**Servicing and Stormwater
Management Report
CHEO Parking Garage
401 Smyth Road, Ottawa, ON**

EXP Project Number: MRK-21023468-A0

Type of Document:
Site Plan Control Application

FIGURE 3 - VHV

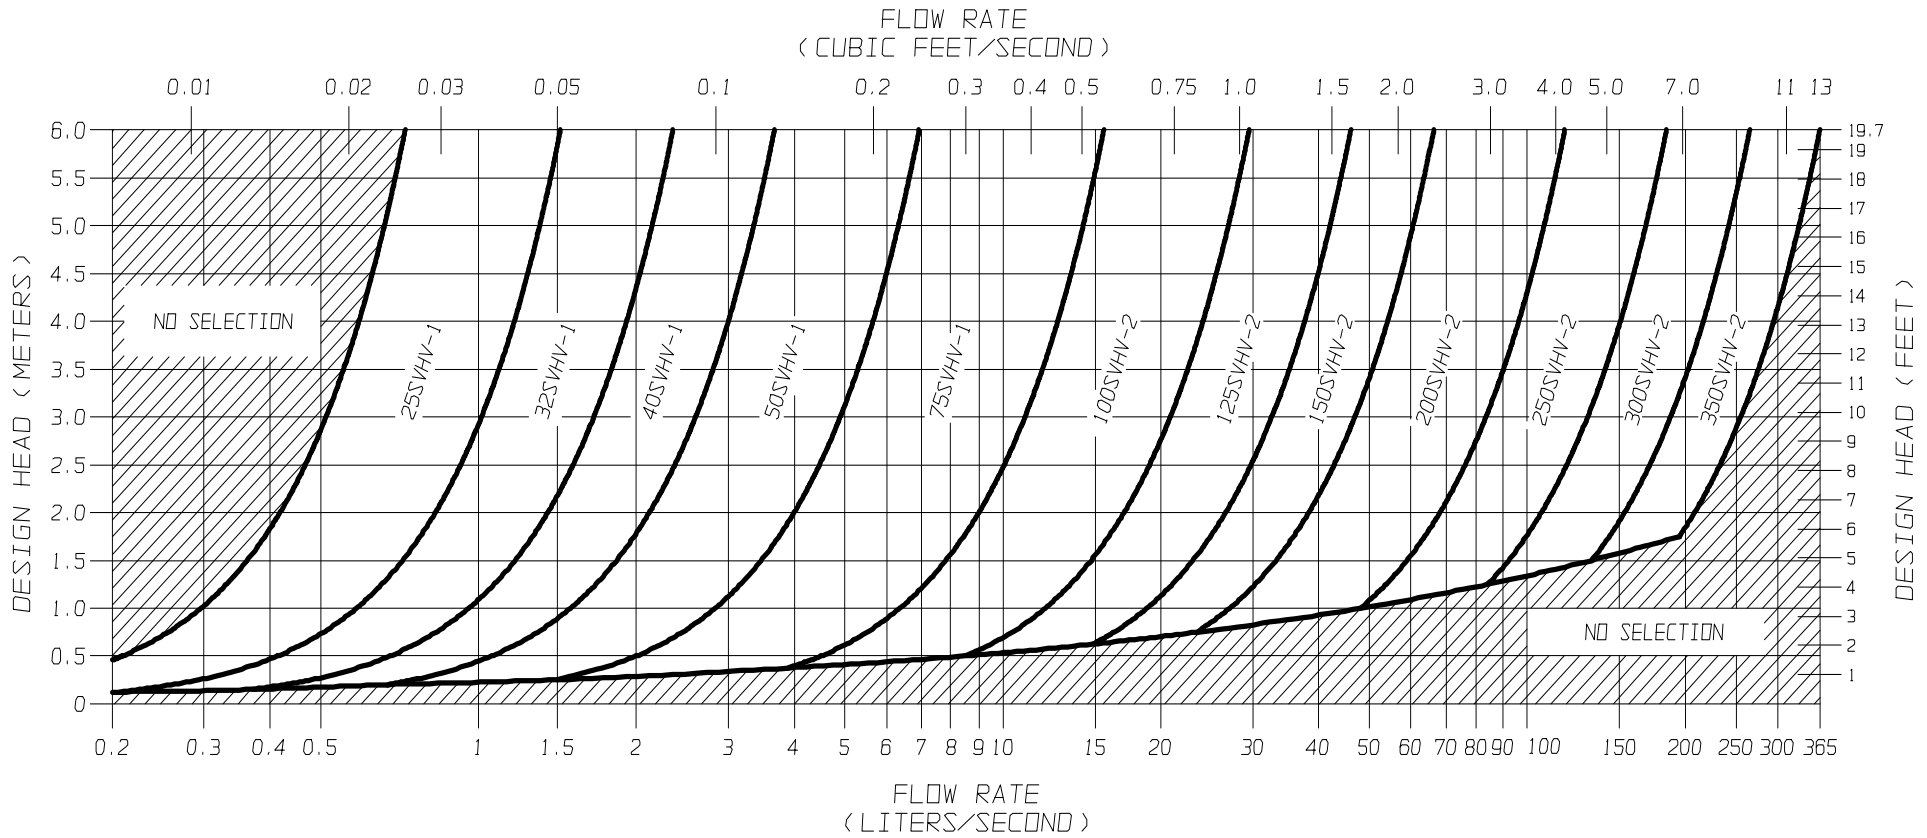
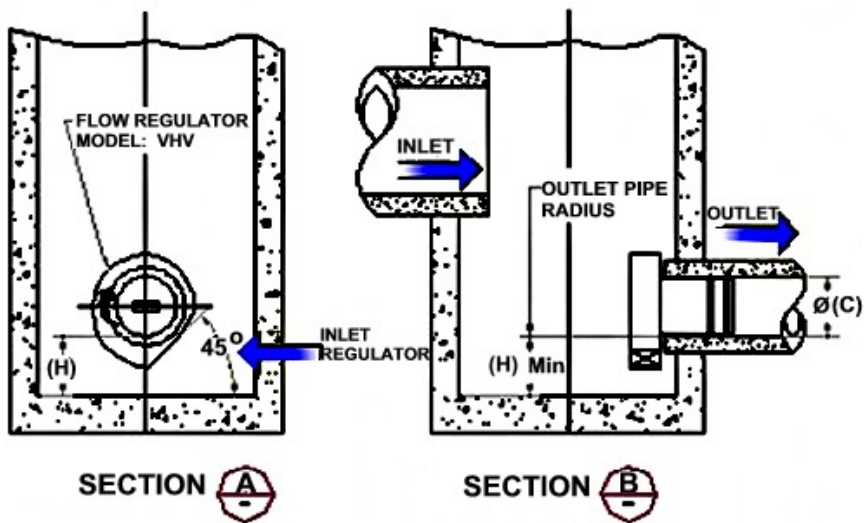
Please provide completed charts to determine which model was selected for each controlled drainage area.

PDC Response: Ok. ProjectCo to clearly identify how ICD models were selected, if applicable.
